## LiDAR Quality Assessment Report

UT\_FEMAHQ\_B2\_QL2\_2018

Project: UT\_FEMAHQ\_B2\_QL2\_2018

Contractor: Quantum Spatial, Inc.

Checkpoint Distribution Image

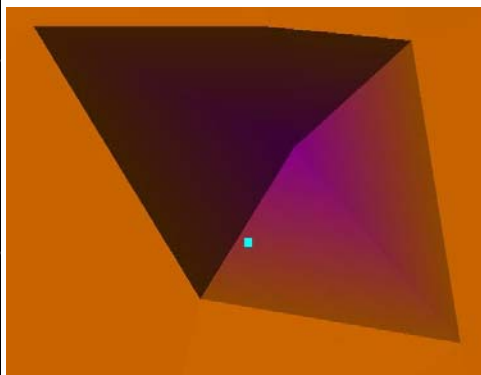
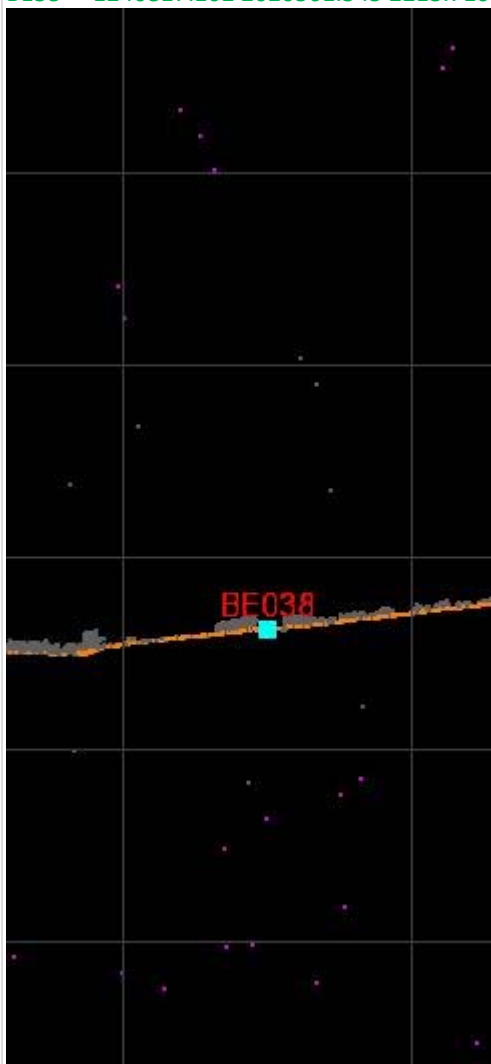
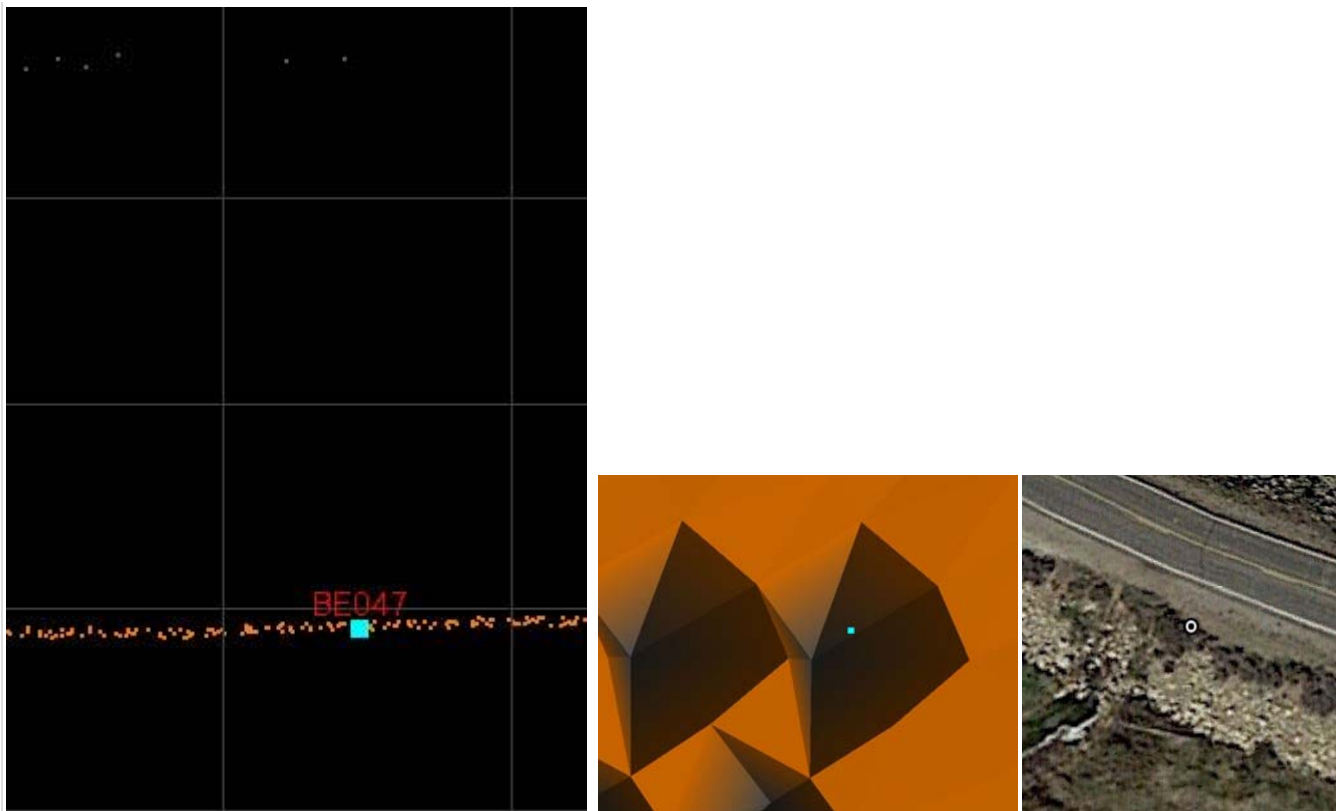
Corrected 5/15/2019 - Points removed from analysis by contractor

- BE38 and BE47 have a DeltaZ over 6.

BE38 -1246817.102 2020561.545 2213.710 2190.125 Control 23.585

BE47 -1212071.899 2009534.697 1788.150 1794.571 Control -6.421

If BE47 ( $zDiff = -6.421$ ) is removed, the VA fails ( $RMSEz = 218.07$  cm).

If BE38 ( $zDiff = 35.828$ ) is removed, the VA fails ( $RMSEz = 58.0$  cm).

If both BE38 and BE47 are removed, the VA passes ( $RMSEz = 3.3$  cm).

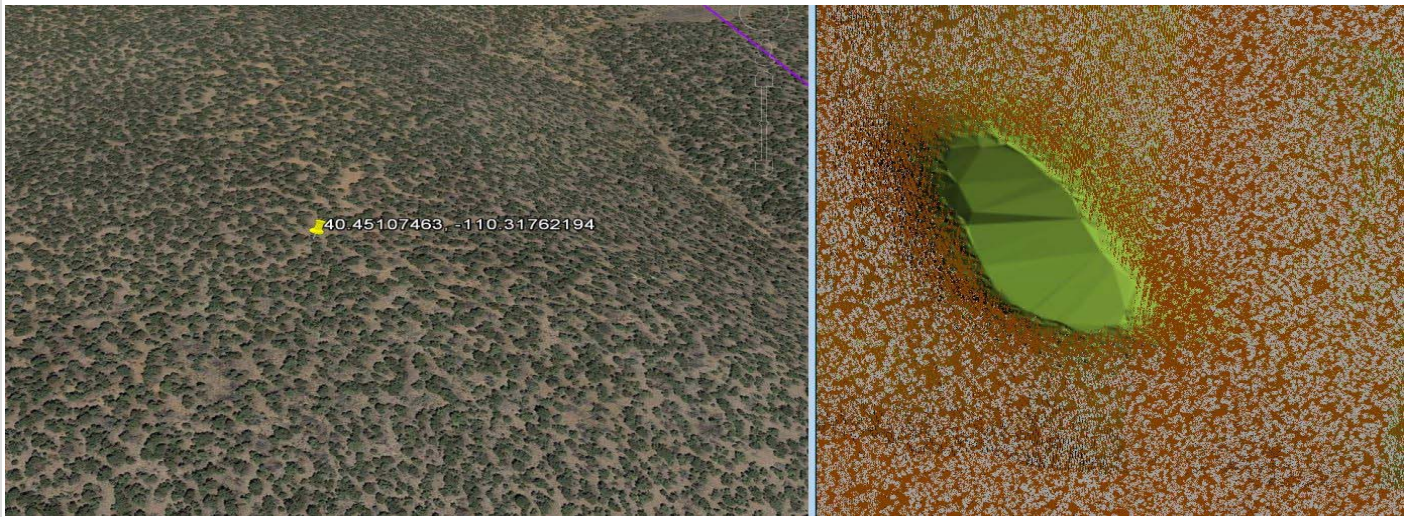
- Las Files have classifications of 10 (1 Las tile), 11 (926 Las tiles), and 14(13 Las tiles). Project Report and Metadata XML's do not contain those classifications.

Corrected 5/14/2019

Examples:

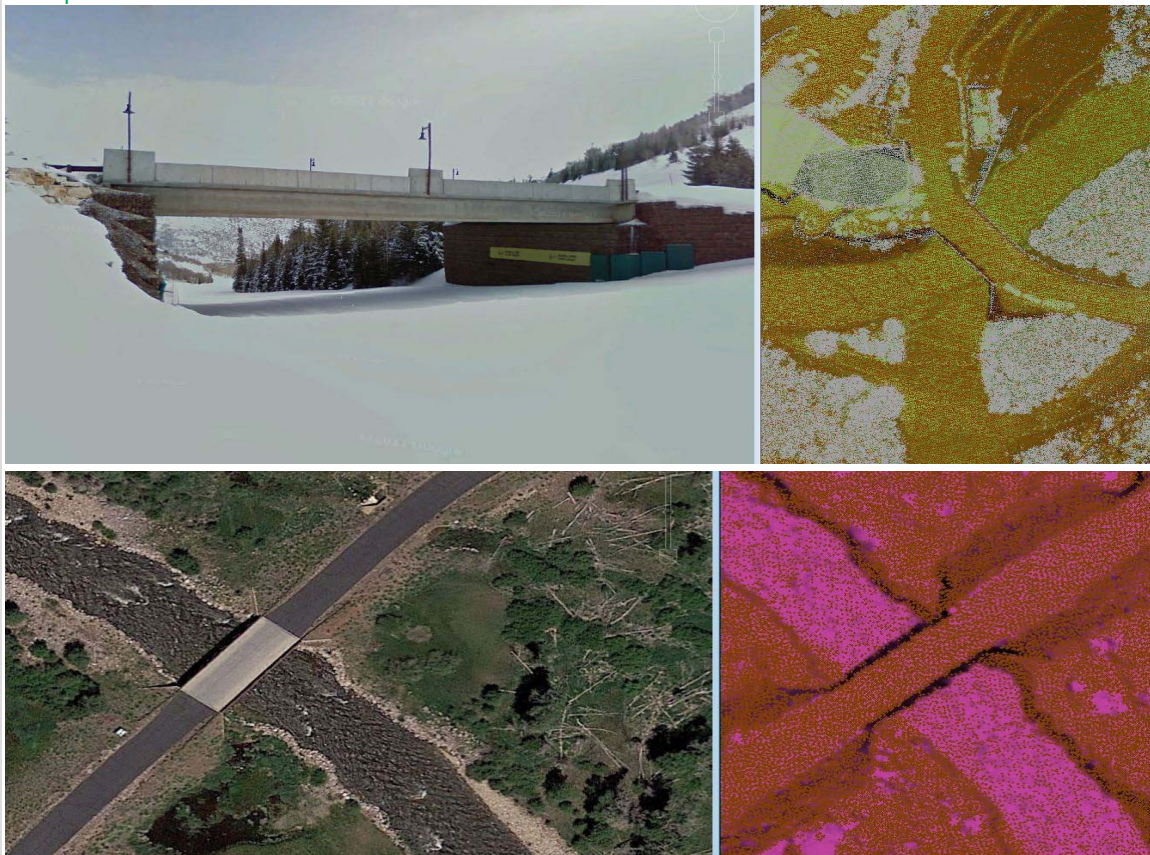
- 3 Bridge areas with points not classified correctly, causing bridges to be left in DEM, see UT\_FEMAHQ\_B2\_QL1\_Errors and UT\_FEMAHQ\_B2\_QL2\_Errors error shapefiles.

Corrected 5/14/2019

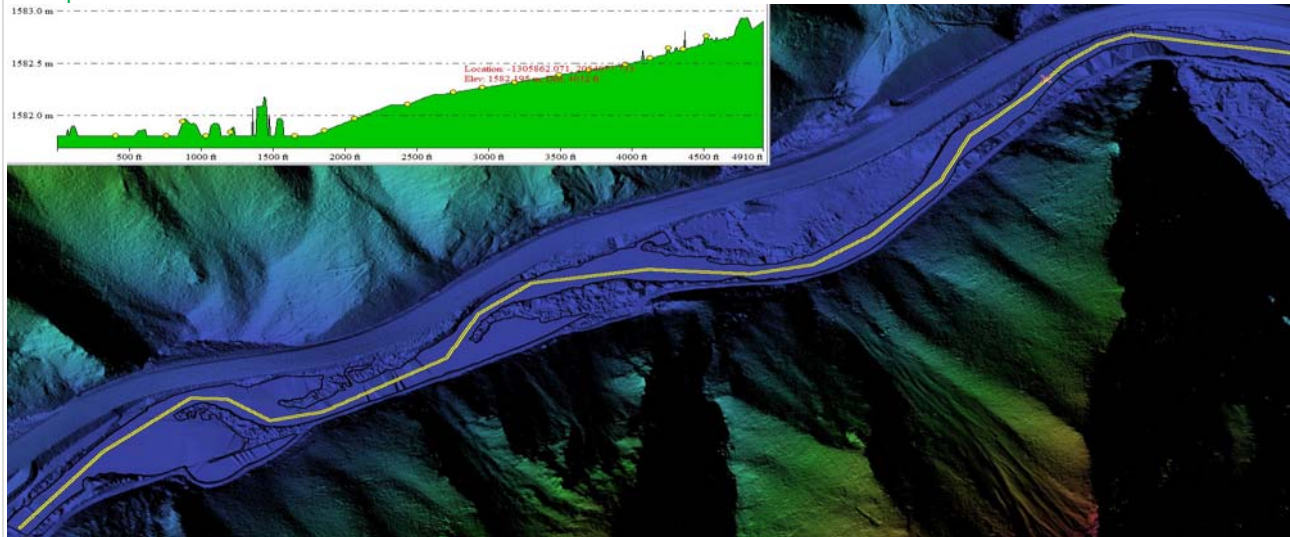
- 1 Lake/Pond > 2 acres not hydroflattened, See UT\_FEMAHQ\_B2\_QL2\_Errors shapefile.

Corrected 5/14/2019

Examples:

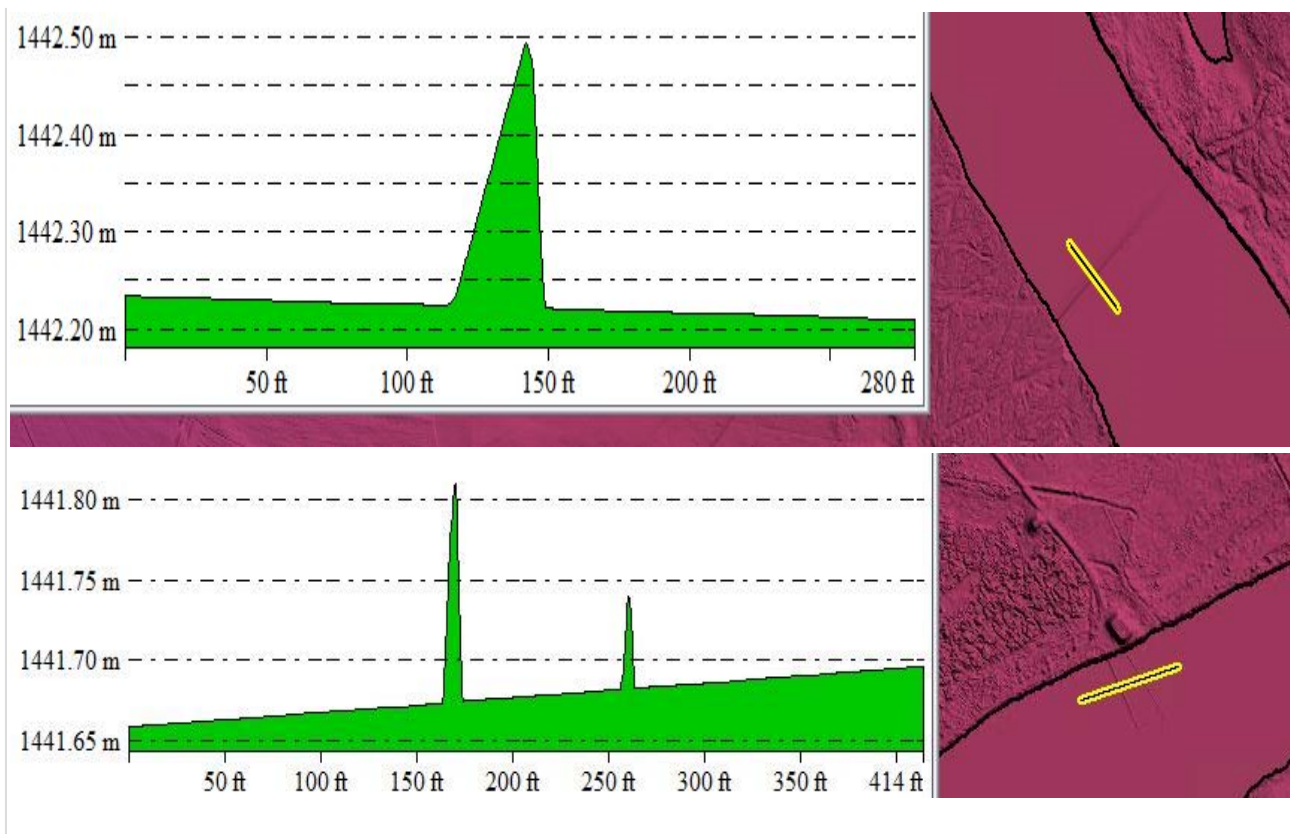
1 Not Corrected 5/14/2019, see UT\_FEMAHQ\_B2\_QL2\_Errors\_v2 shapefiles.

- 23 River sections not hydroflattened correctly, rivers have spikes or floating water, see UT\_FEMAHQ\_B2\_QL1\_Errors and UT\_FEMAHQ\_B2\_QL2\_Errors error shapefiles.

Corrected 6/13/2019
